SUBJECT: Transmittal of Revised Responses to AP1000 DSER Open Items

AP1000 Design Certification Review  
Draft Safety Evaluation Report Open Item Non-Proprietary Responses

DSER Open Item Number: 2.3.4-1 Revision 2

**DSER Open Item Number:** 3.8.4.5-2 (Response Revision 2)

Figure 15A-1

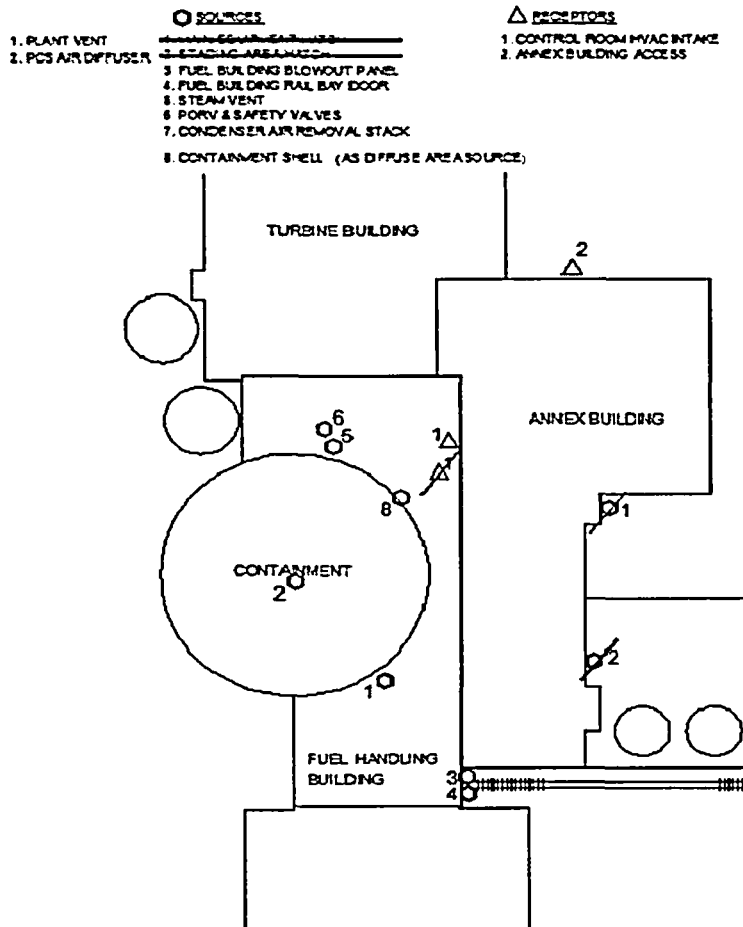
Westinghouse submitted revisions to address this question in DCD Revision 7. The staff had further questions in response to those revisions, particularly relating to the modeling used in the demonstration case control room  $\chi/Q$  values.

3. A set of  $\chi/Q$  values for typical site meteorology and plant orientation have been calculated in accordance with the guidance set forth in Regulatory Guide 1.194. The purpose of the calculation is to define the modeling assumptions for calculating the control room  $\chi/Q$  values for AP1000, and will serve as an example of an approved method for the COL applicant to follow to determine the acceptability of their site to meet the control room  $\chi/Q$  values. Relevant portions of this calculation are now included in DCD Appendix 15A.

The ARCON96 modeling approach used (as illustrated in attached DCD mark-up, Table 15.A-7 and Figure 15A-1) is fully in compliance with Regulatory Guide 1.194.

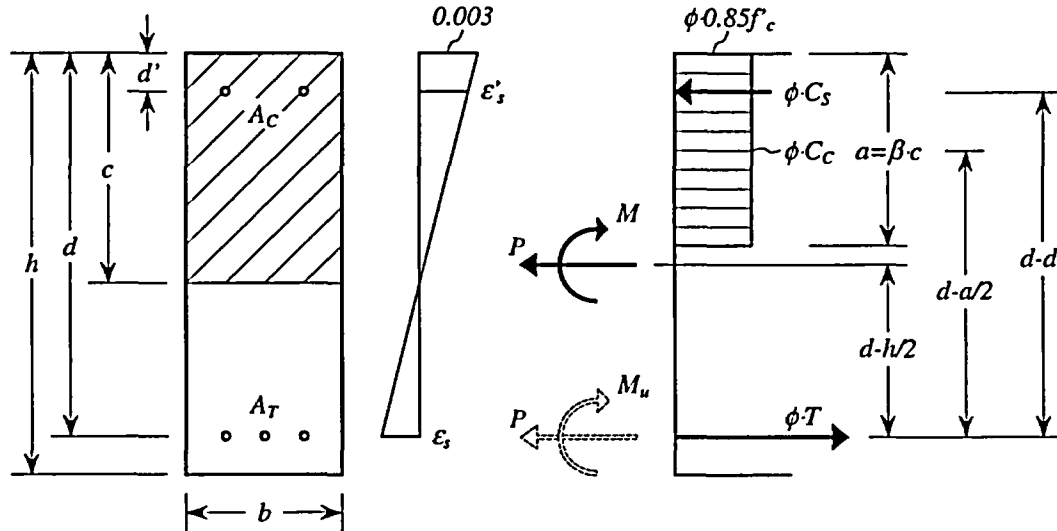
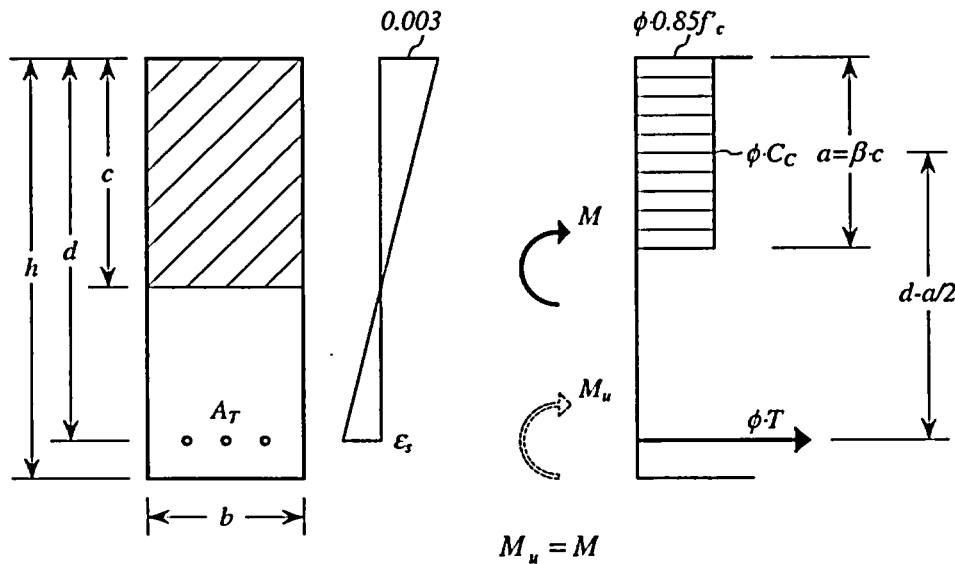
During the course of its review of the Wall 7.3 design calculation, the staff noted that the applicant had previously identified and corrected an error in the equation used by INITEC to calculate the required positive reinforcement for a section subjected to both bending moment and axial load. The staff could not conclude during the audit that the corrected equation accurately calculates required positive reinforcement. Therefore, the applicant was requested to submit the derivation of the equation currently used to calculate the required reinforcement. The applicant was also requested to submit a sample verification calculation for the computer algorithm, and verify that the corrected equation has been utilized in all calculations. This is Open Item 3.8.4.5-2.

The Revision 0 response only showed development of equation for one case (axial plus bending with both tension and compression steel at yield). Clarify how range of applicability is checked and what other cases are used in the macro or explain how design engineer is told that the case is out of range of applicability.

The development of the equation for sizing the required reinforcement for a section subject to bending moment and axial load is shown in this response. This equation is applicable when the strength of the section is controlled by yielding of the tension steel and both tension and compression steel, if any, are at yield. Loads and internal forces are shown in the following figures. The design loads  $P$  and  $M$  act at the centroid of the section, where:

The strength reduction factor  $\phi$  is applied to both the steel and concrete strengths to obtain the design strength as shown in the figures.

Figure 3.8.4.5-2-1  
Axial Load-Moment Interaction Diagram

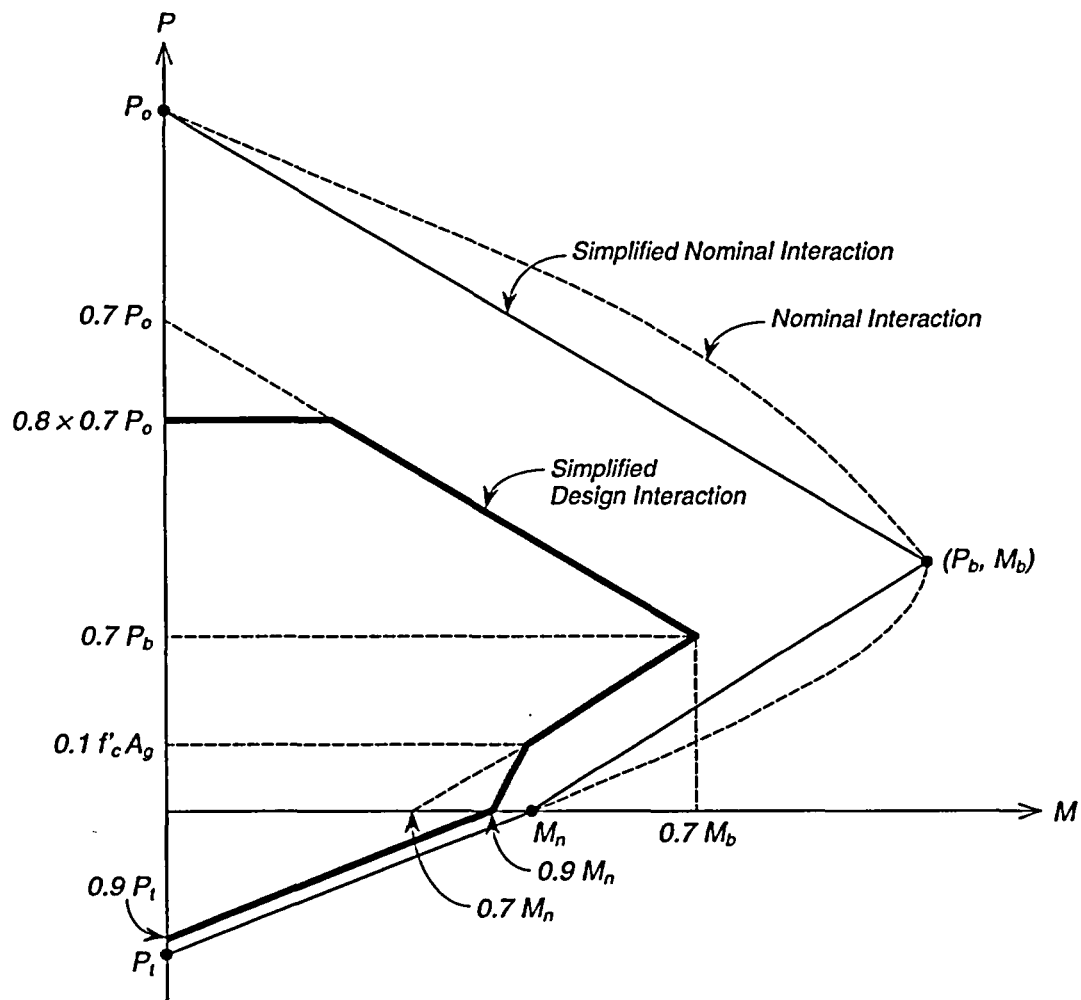
**Confirm that the guidance described in revision 1 of this response has been implemented in the design of the critical sections.**

Figure 3.8.4.5-2-1 shows a typical interaction diagram defining the strength of a concrete section under combined axial force ( $P$ ) and bending moment ( $M$ ). It shows the nominal strength interaction as well as a simplified nominal interaction based on straight lines connecting the following key points:

The simplified design interaction diagram is also shown. This is obtained by applying the code specified strength reduction factor ( $\phi$ ) to the simplified nominal strength diagram.

The nominal axial load strength at balanced strain conditions,  $P_b$ , provides a convenient division point between compression and tension failures (Ferguson "Reinforced Concrete Fundamentals"). This strength is based on the reinforcement provided. When the nominal axial compressive forces are less than  $P_b$ , the tension reinforcement is at yield and the compression reinforcement is at or close to yield. Hence the results of the macro are accurate for design axial member forces less than  $P_b$ . The macro is used for multiple load combinations and the controlling cases for reinforcement demand are those with axial tension (or smallest compression).

Guidance is being provided to the engineer to perform an additional check when the axial compressive forces are greater than  $\phi P_b$ . In this additional check the axial load-moment interaction diagram is calculated for the reinforcement that has been selected based on use of the macro. Combinations of design moments with axial forces greater than  $\phi P_b$  are reviewed and confirmed to be bounded by the interaction diagram.
